Proposed Railyard Development,  
Albert Quay, Cork

STAGE 1 ROAD SAFETY AUDIT  
March 2024

<b>Client</b>	Progressive Commercial
<b>Project Title</b>	Proposed Railyard Development
<b>Project Location</b>	Albert Quay, Cork
<b>Document Title</b>	Stage 1 Road Safety Audit
<b>Document No.</b>	24027RS-MHL-Doc01-Railyard Devt-RSA
<b>Job No.</b>	24027RS

**Figure 1.2: Proposed Development Site Layout (Credit: CSR Landscape Architects)**

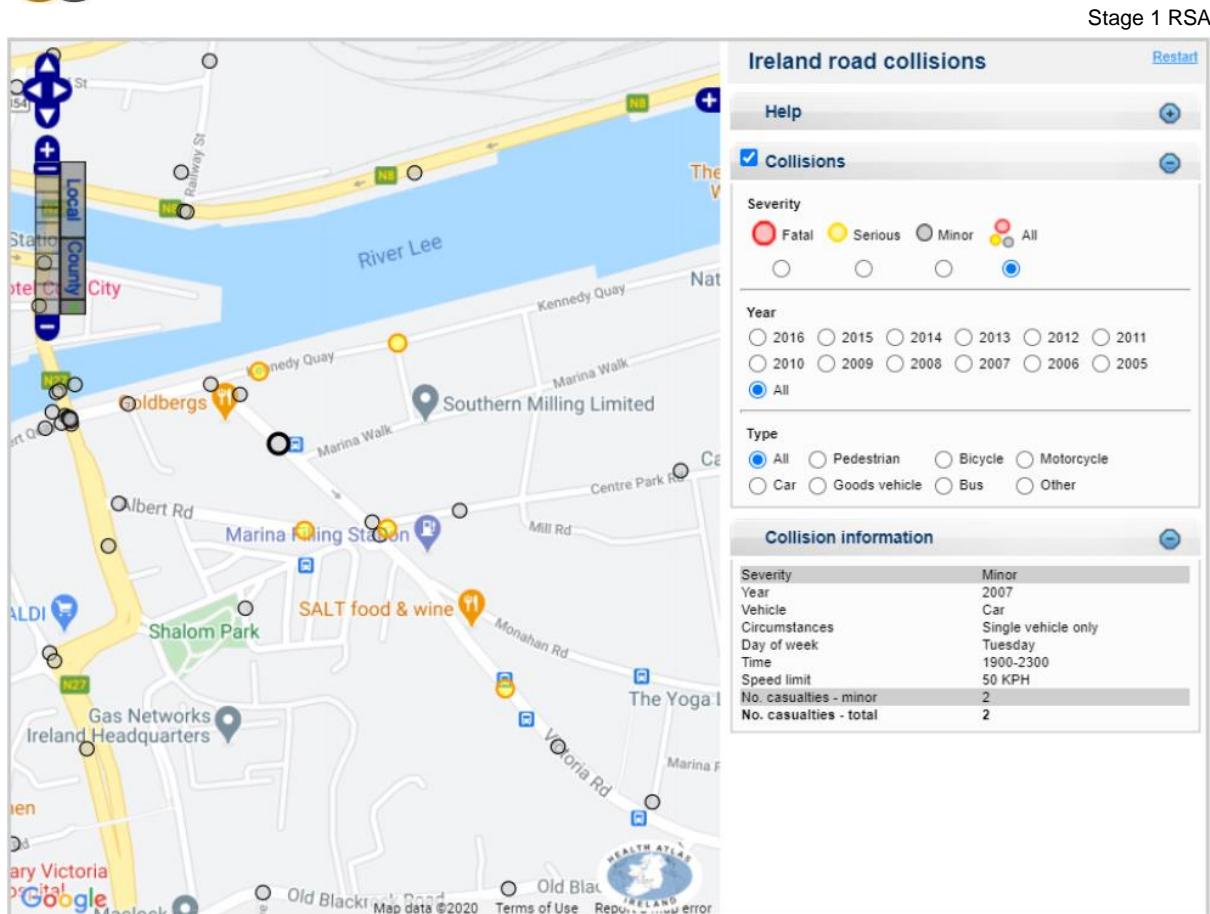
No surface water services are shown on the proposed development site layout drawing provided to the audit team. Failure to install suitable surface water services may lead to excessive water along footpaths and on the road edge and potentially result in icy surfaces, leading to collisions between vehicles travelling in opposing directions.

The scheme incorporates a proposed sit-down area along Albert Quay, on the northern road edge. This sit-down area will serve private car drop off's, taxi set-down and delivery movements. No road markings outlining its restricted function or integration with the existing cycle lane or future bus lane are presented. Failure to clearly assign a use of this space may result in it being used for permanent parking requiring taxi's and delivery vehicles to set-down at an unsafe and undesignated location, potentially leading to collisions involving passing vehicles and/or cyclists.

Install surface water collection infrastructure in accordance with appropriate design standards.

Provide appropriate signage and road markings to present the intended use of the set down area, in accordance with relevant design standards. Ensure that appropriate road

markings are also employed to ensure that the bus lane and/or cycle lane are adequately highlighted in the vicinity of the facility.
